NFPA Technical Committee on Fire Doors and Windows (FDW-AAA) NFPA 80 and NFPA 105 First Draft Meeting (A2027)

November 10-12, 2025
8:00 a.m. (MT)

Figure A.4.7.4.2(k) Rolling Steel Doors — Surface Mounted.

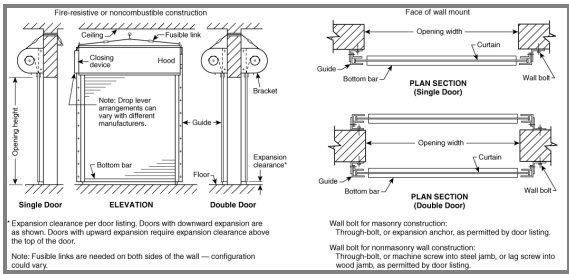
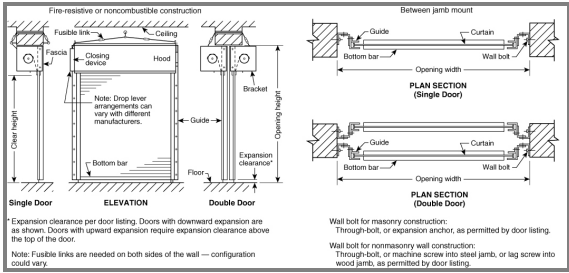
Proposed language to provide explanatory verbiage addressing frequently asked questions regarding section 4.7.4.2 and A.4.7.4.2 (k) pertaining to Exterior Wall Applications.
